Henderson Highway North Improvements Study

Phase 1 Public Engagement Summary

May 2022

Figure 1: Clusters of pins placed on the mapping tool

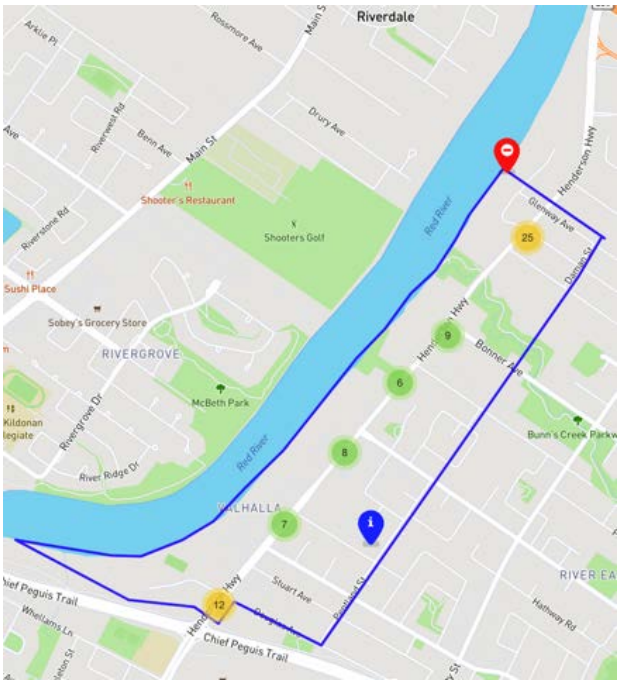
The public was invited to add virtual pins to an interactive map to highlight current issues along the corridor. A total of 69 pins were added to the map, including one access issue pin, 36 infrastructure issue pins, and 32 safety issue pins. Participants were asked to add a comment to their pin describing the issue. The issues were coded for themes. Figure 2 outlines the top themes.
